SEWAGE DISPOSAL SYSTEM
HOWARD COUNTY HEALTH DEPARTMENT
BUREAU OF ENVIRONMENTAL HEALTH
410-313-2640

P 514650
A 510569-B
ISSUE DATE 11/15/2000
APPROVAL DATE 12/11/00
(Septic Inst)

SUBDIVISION Eagle Ridge LOT NUMBER 2 ADDRESS 12315 Fawn River Way
12258 Carroll Mill Road

Re: New Construction Variance
12315 Fawn River Way
Ellicott City, Maryland 21042

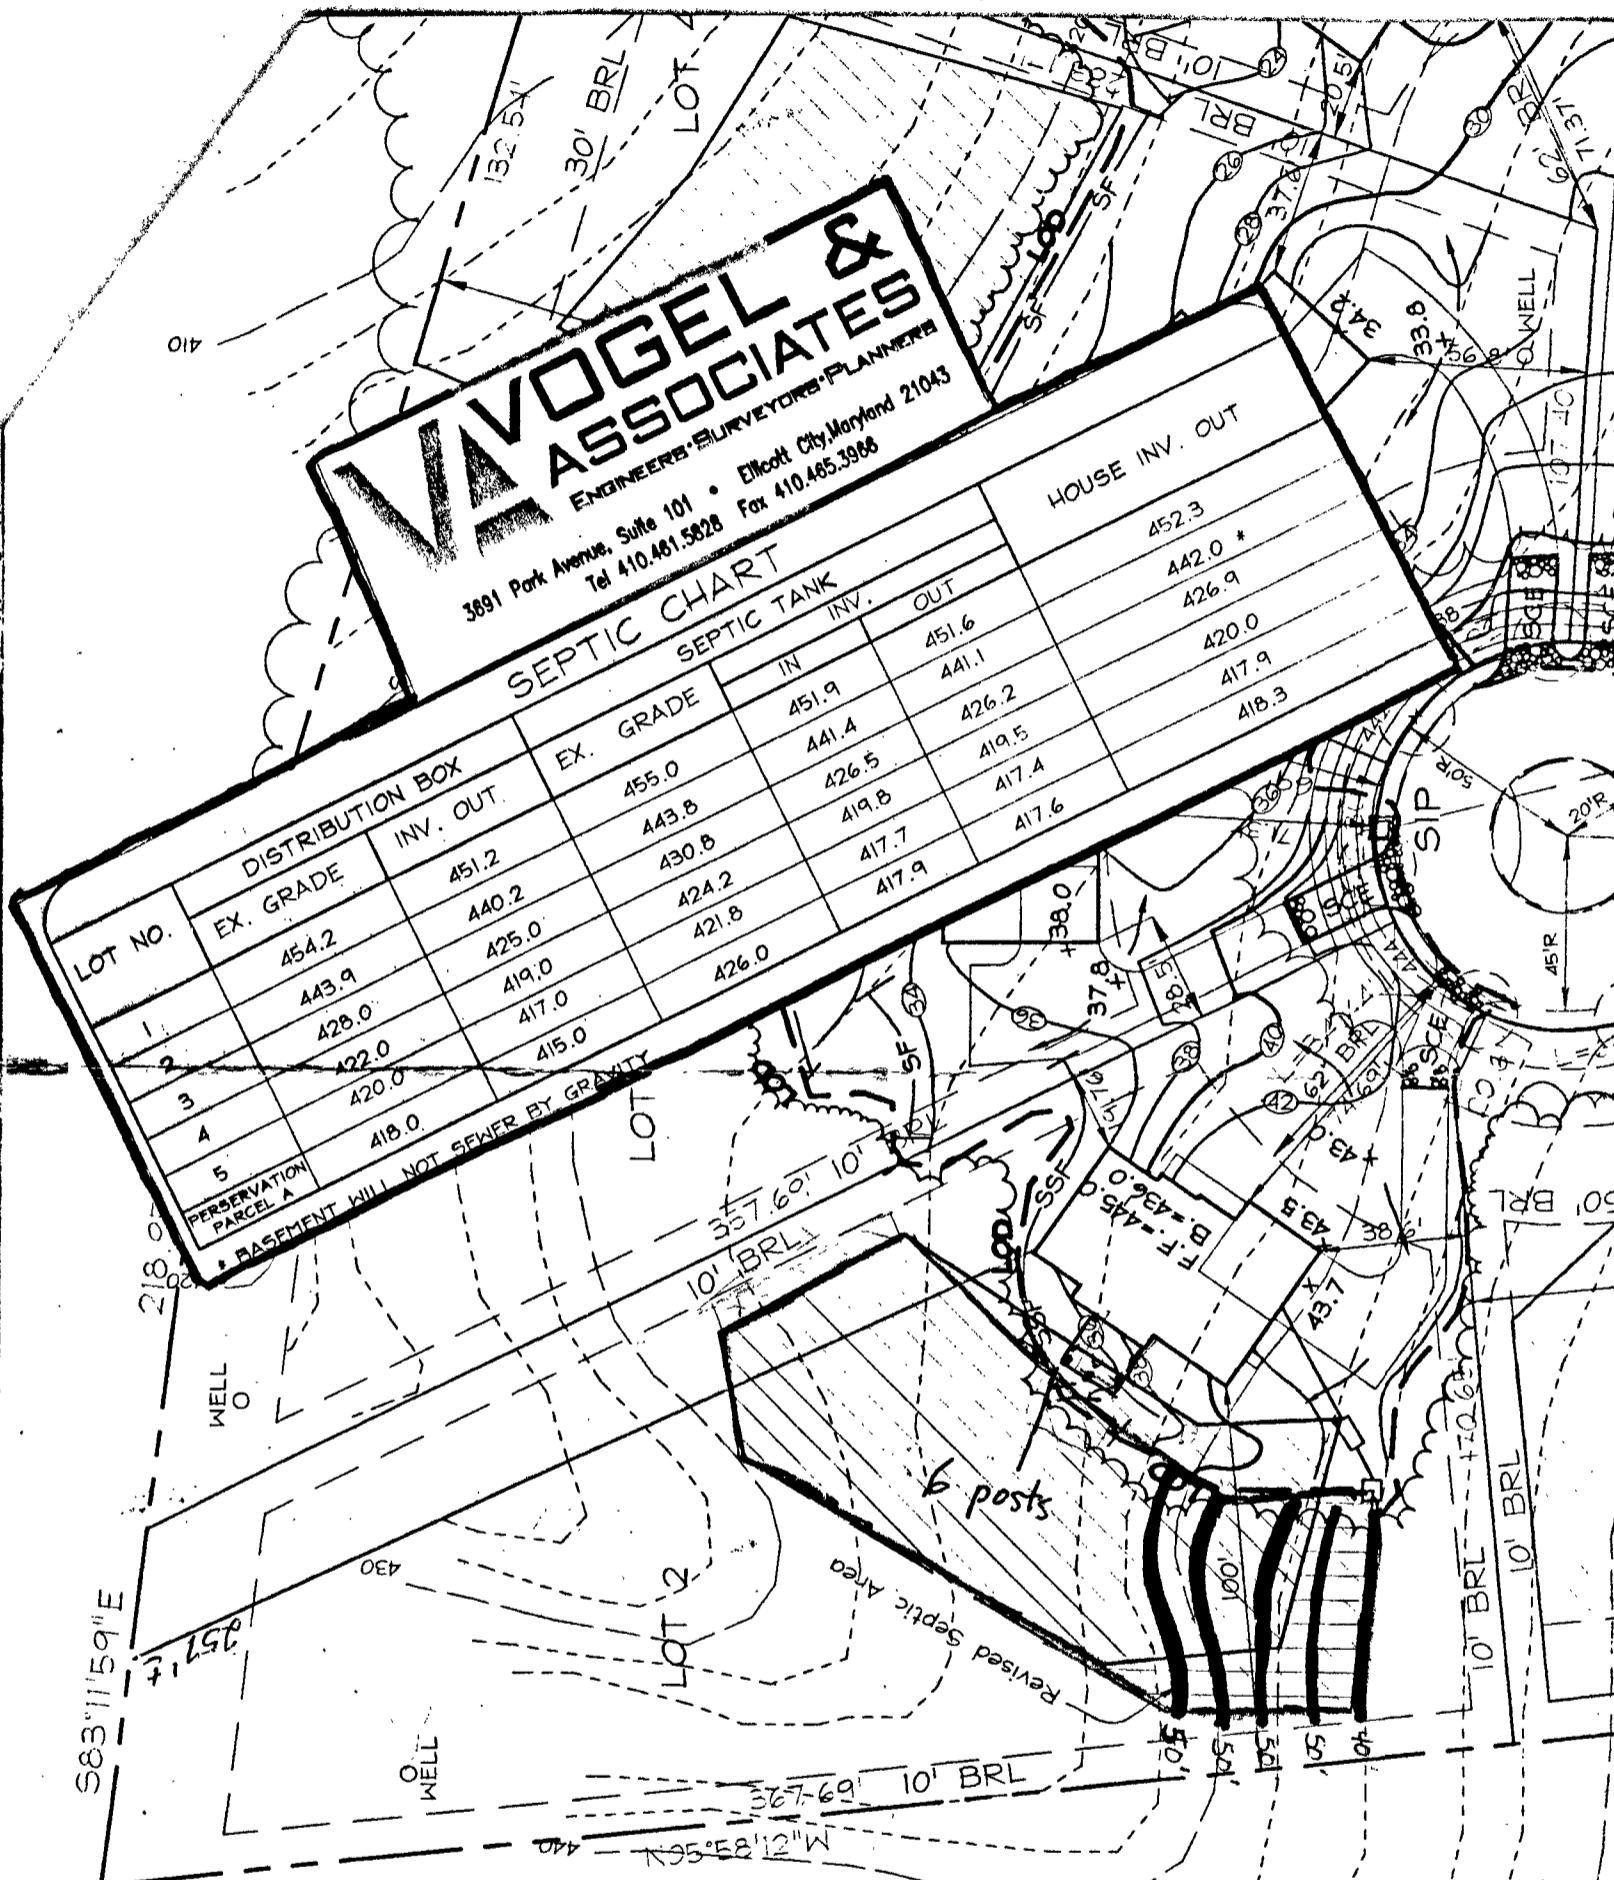
PRE-CONSTRUCTION INSPECTION: 12/6/00 GRAVITY FLOW NOT POSSIBLE; 2 S.T. TO BE INSTALLED FOR FUTURE PUMPING; OK TO PLUMB 1/3 DOWN THE HILL (M)
 INSPECTION COMMENTS: 12/7/00 Tank set (BB) 12/8/00 - OK TO COVER FROM HOUSE TO BOX, MANHOLE RISERS TO BE INSTALLED (SRW) (Baffles in S.T. + P.C. see notes)
Trenches OK to cover, OK to cover all work R/P 12/11/00

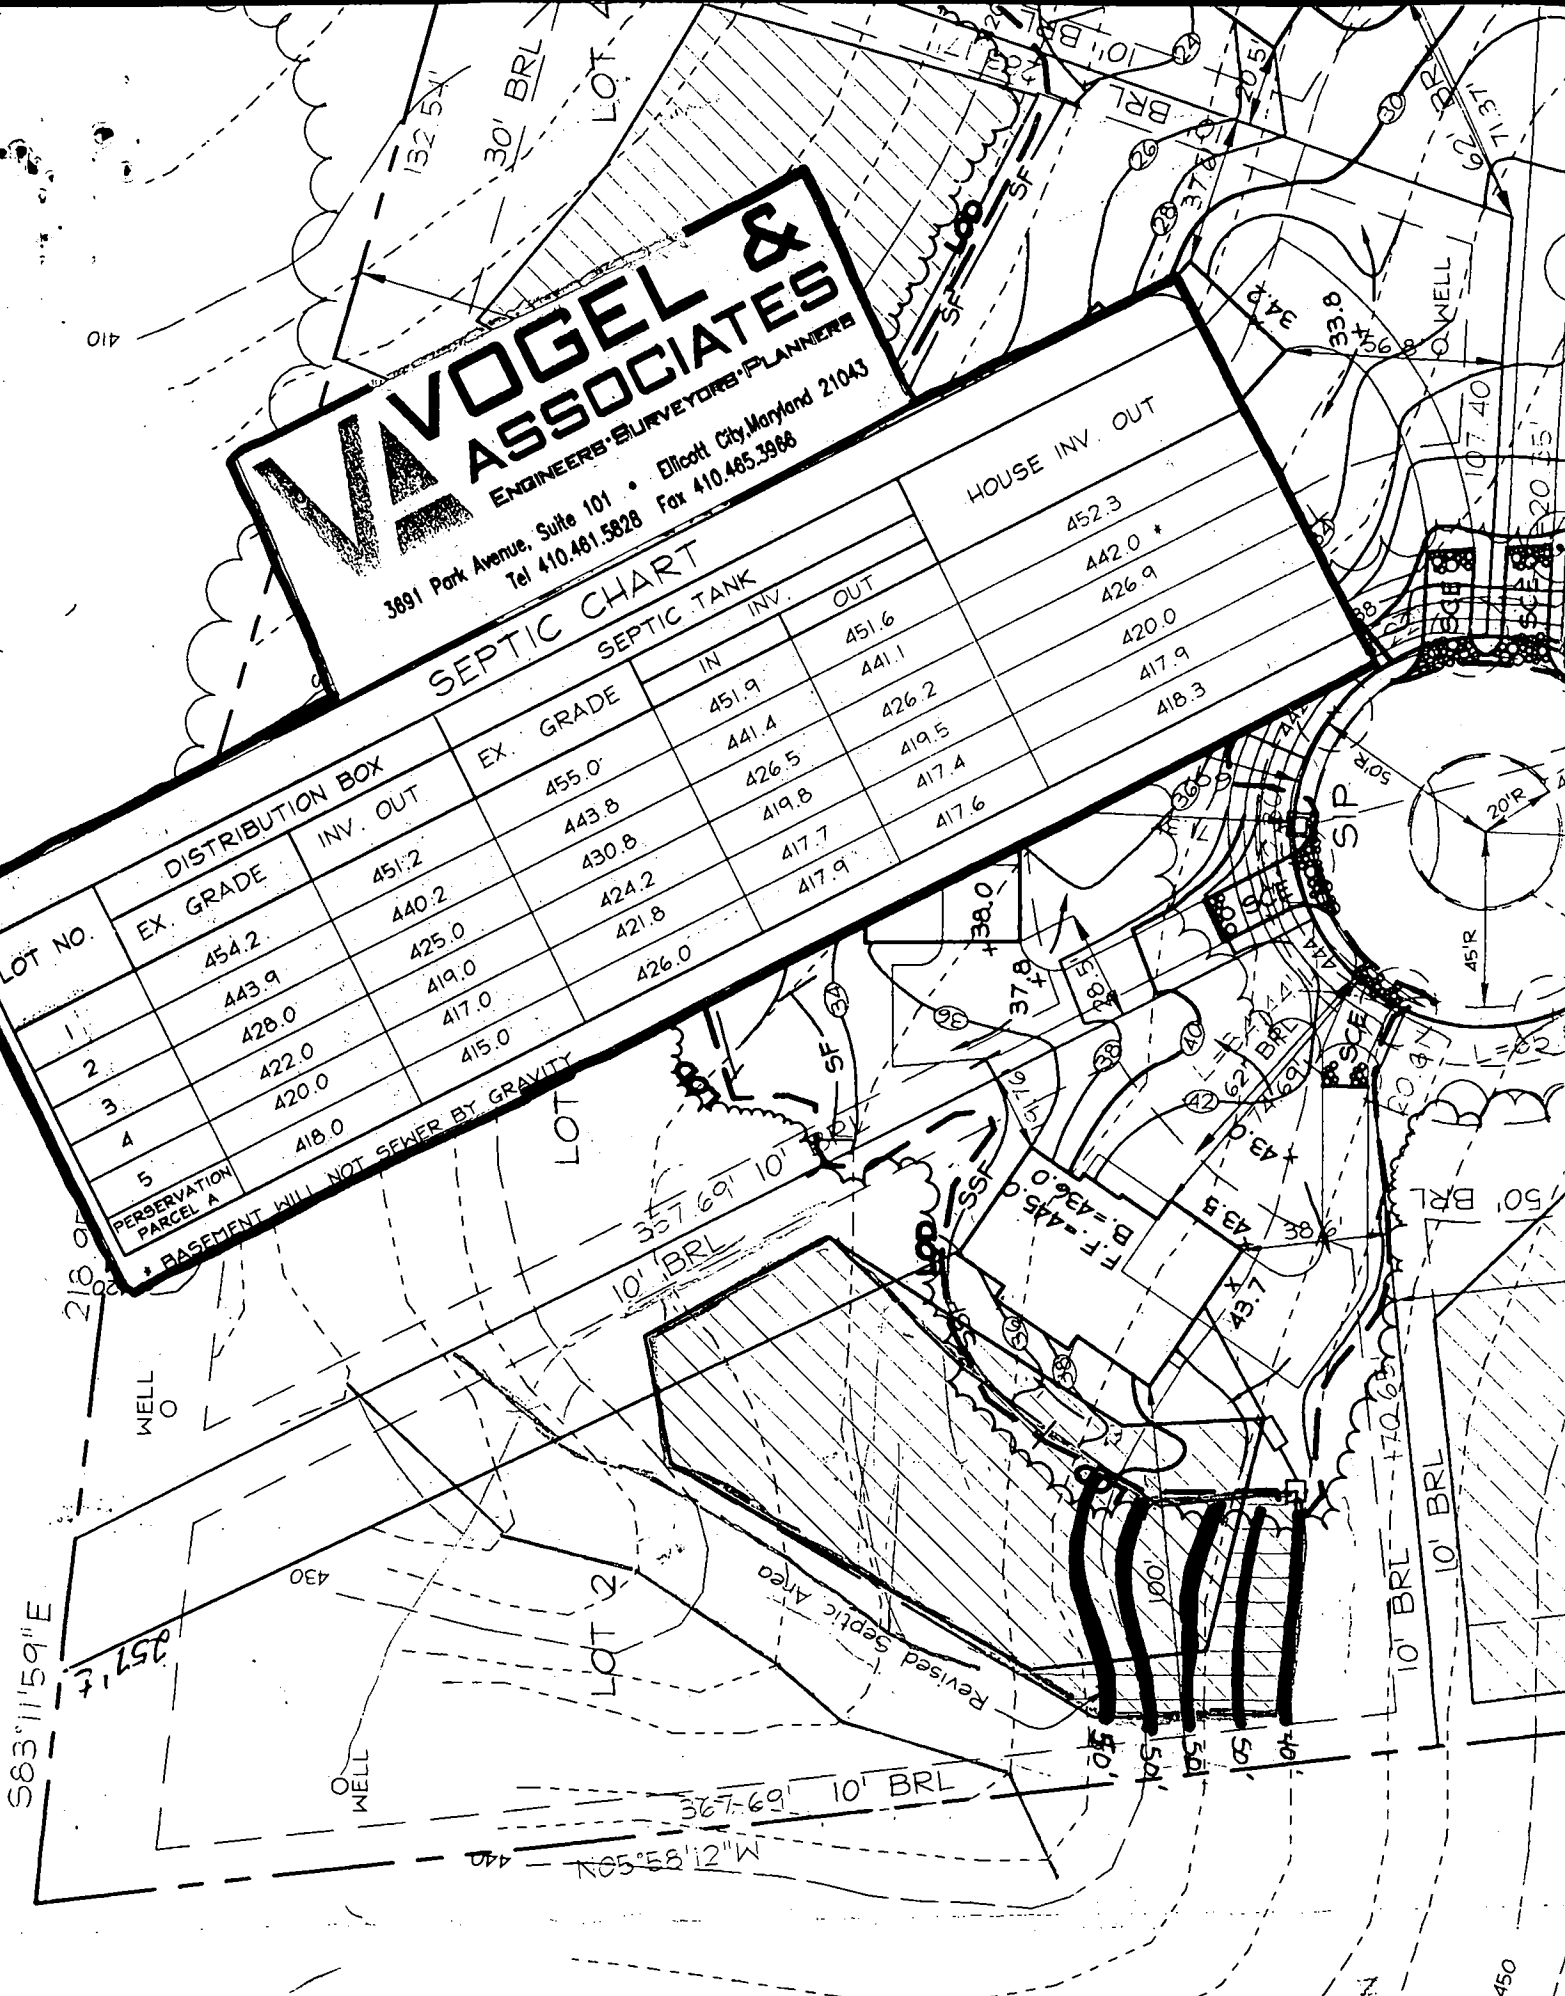
BASEMENT WILL NOT SEWER BY GRAVITY

A-5 KNEEWALL SETOUT
 1 SCALE - 1/4" = 1'-0"

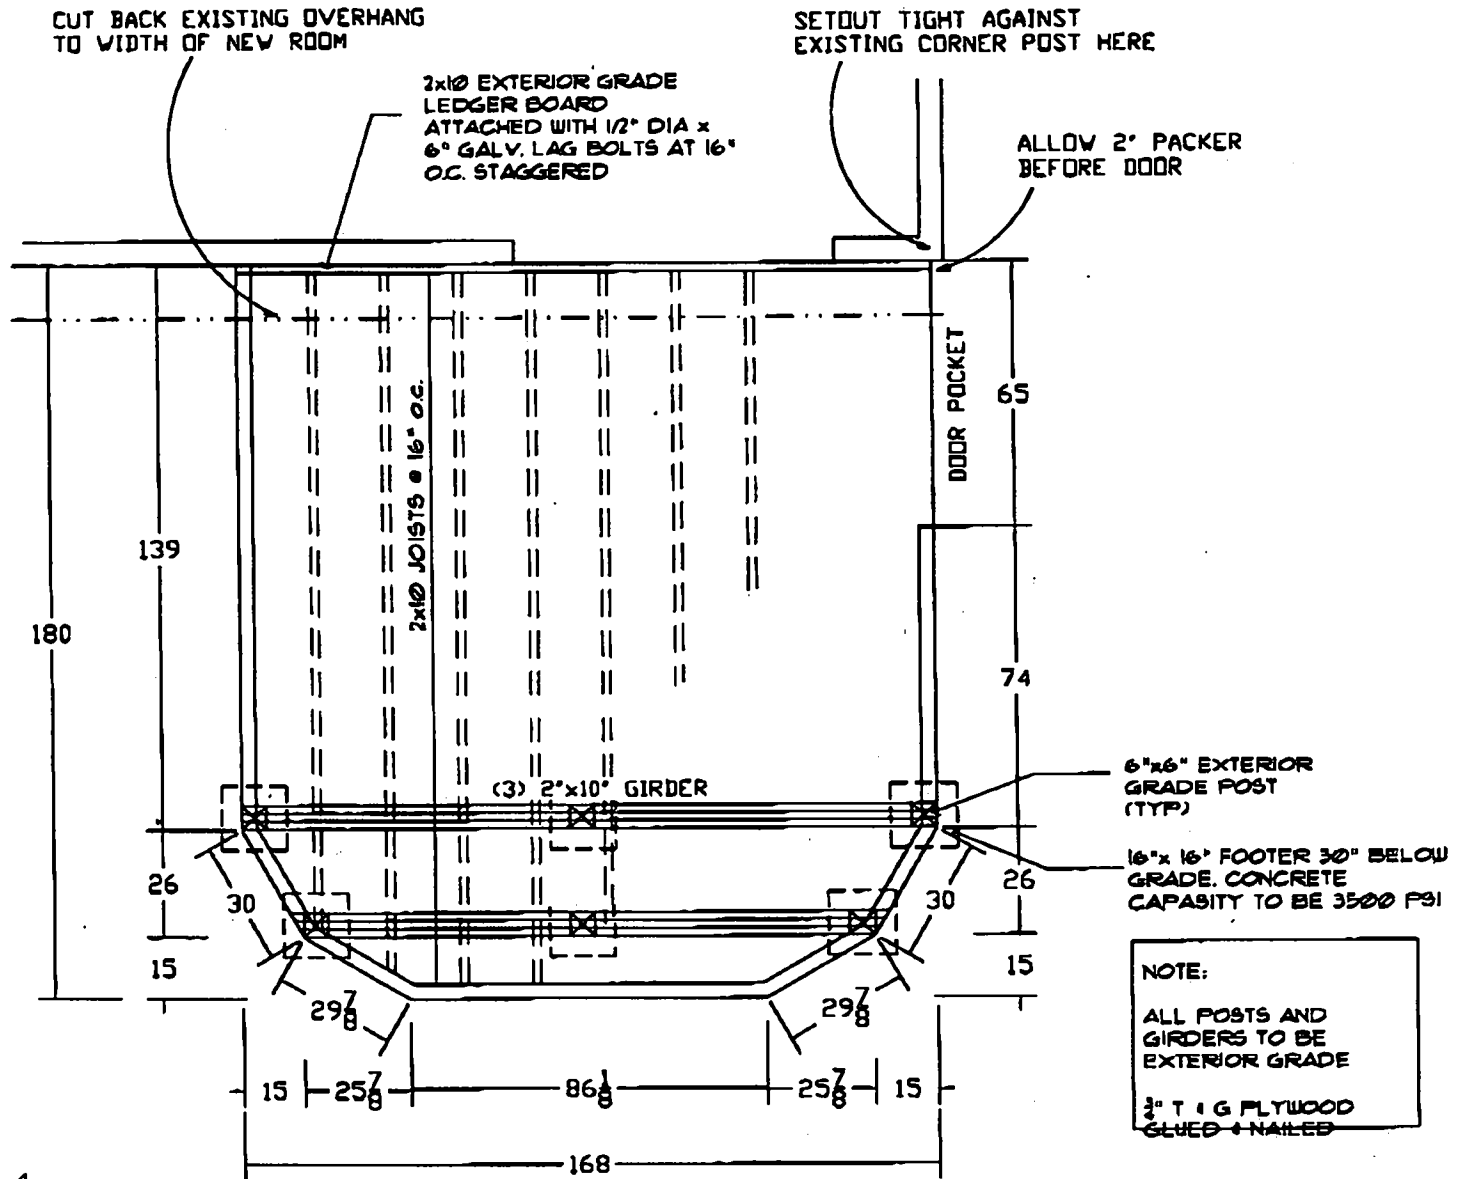
We are planning to build a small room addition (approximately 210sf) on the rear of our house. However, the addition will be built on a portion of the buffer area for the easement of the septic system. We are requesting a variance so that we may proceed with the construction.

The addition will be constructed on a **post and pier foundation** and the room dimensions will be approximately fourteen feet by fifteen feet. To aid the decision process for granting the variance we have enclosed the following:

1. Complete set of construction drawings for the addition.
2. Plat of the property located at 12315 Fawn River Way, Ellicott City, Maryland with the current home, septic easement and proposed addition all drawn to-scale. The location of the posts have also been noted on the drawing.

We have received a variance requesting the required 10' setback to sewage disposal easement for a structure that is to be built on a post and pier foundation at the above referenced property be waived to 5'. This agency will grant your approval for the variance at the property as long as no part of the deck overhang is within 5' of the sewage disposal easement and post and pier footers are utilized.
